STAFF REPORT
(One-Step Final Plat)

CASE NUMBER: SUB 2005-34 -- THE ROYAL MAGNOLIA ADDITION

LOCATION: South side of 37th Street North, West of Maize

VICINITY MAP

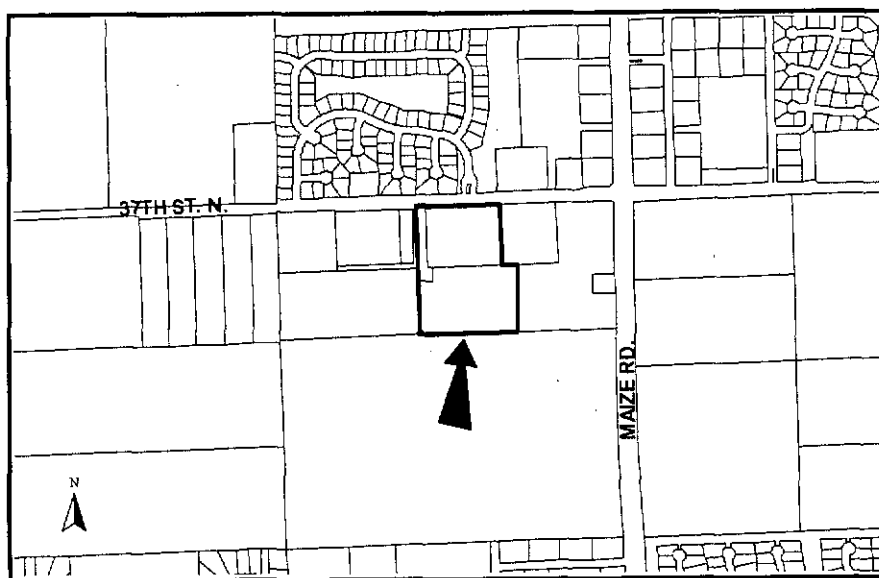
- D. City Engineering needs to comment on the status of the applicant's drainage plan.
- E. The diagonal portions of the drainage and utility easements need to be located.

- F. The dimension of 1015.12 in legal description needs to be checked.
- G. Traffic Engineering has requested the access openings be defined as denoted on the PUD site plan. The plat proposes two openings along 37th Street North. Distances should be shown for all segments of access control. A restrictive covenant shall be submitted that requires the closure of the east opening on Lot 2 upon the establishment of a commercial use.

- I. A cross-lot access agreement shall be submitted that permits cross-lot access through Lot 2 for the benefit of Lot 3. The southwestern adjoiner should also be contacted regarding this access agreement.

- J. A Block shall be designated on the face of the plat as referenced in the plattor's text on the final plat.
- K. The signature line for the Deputy within the Register of Deeds certificate needs to be revised to reference "Tonya Buckingham".

- L. Approval of this plat will require a waiver of the lot depth to width ratio of the Subdivision Regulations for Lot 1. The Subdivision Regulations state that the maximum depth of all residential lots shall not exceed 2.5 times the width.
